Notification subject: ERRATA - PIC18F24K20/25K20/44K20/45K20 Silicon Data Sheet Errata
Silicon Die Revision Addition

Notification text: SYST-18KADG401

Description of Change: Addition of silicon die revision AF.

Silicon Errata and Data Sheet Clarification

1. Module: Dimensions for UQFN Packaging Option

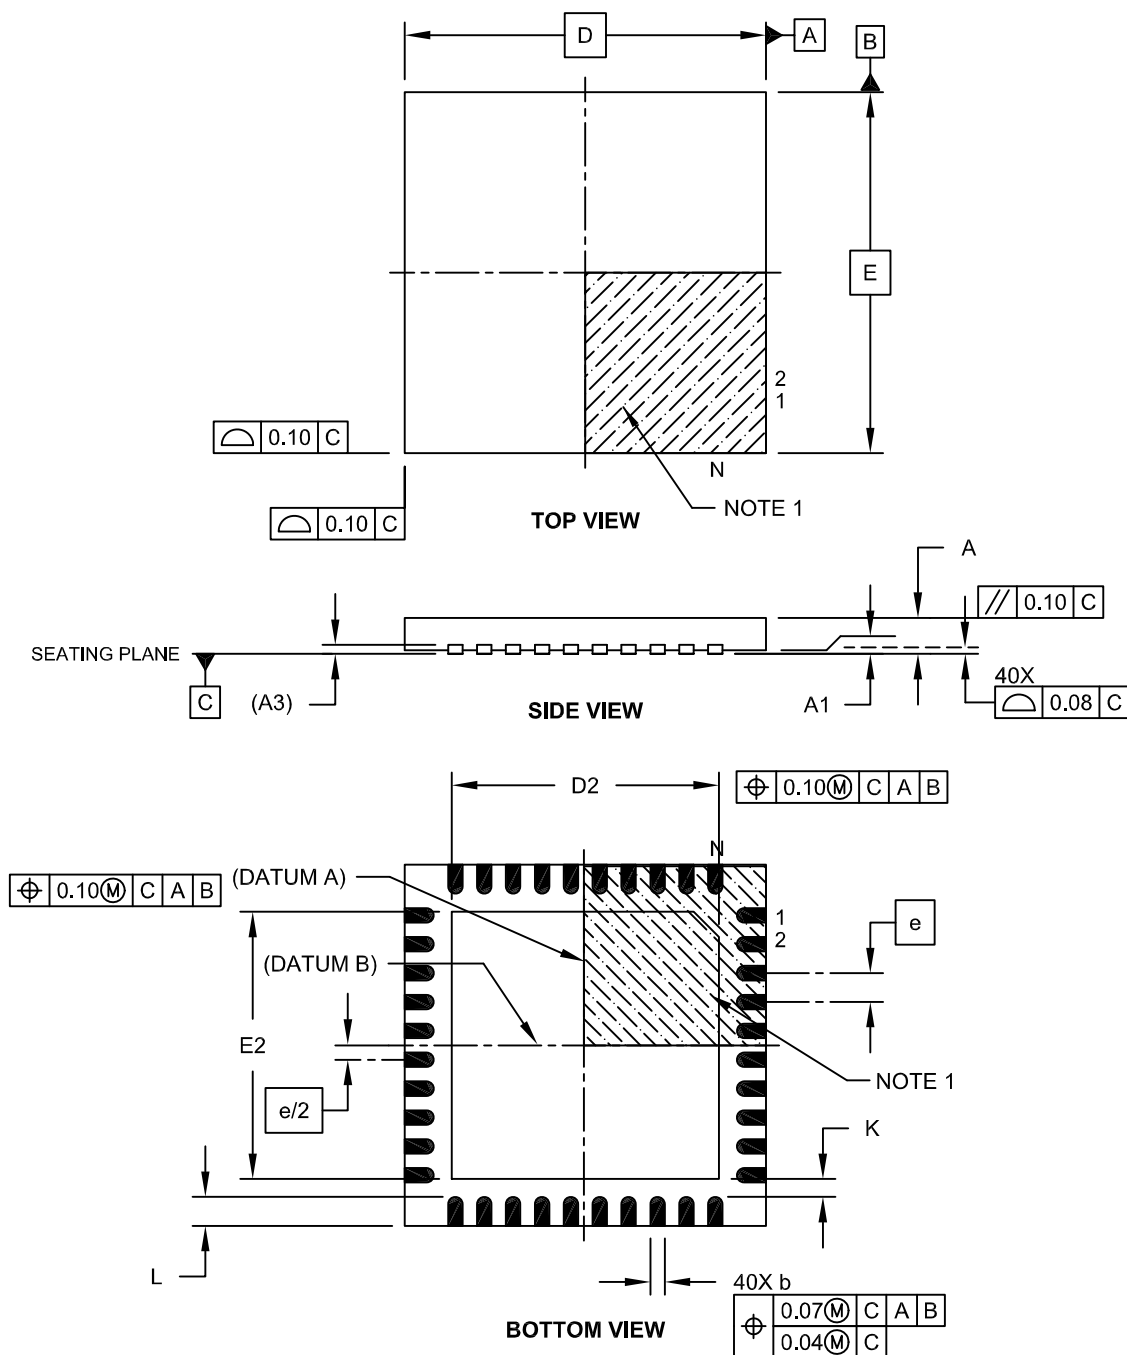
The following typographic corrections and clarifications are to be noted for the latest version of the device data sheet (DS41303G):

40-Lead Ultra Thin Plastic Quad Flat, No Lead Package (MV) – 5x5x0.5 mm Body [UQFN]
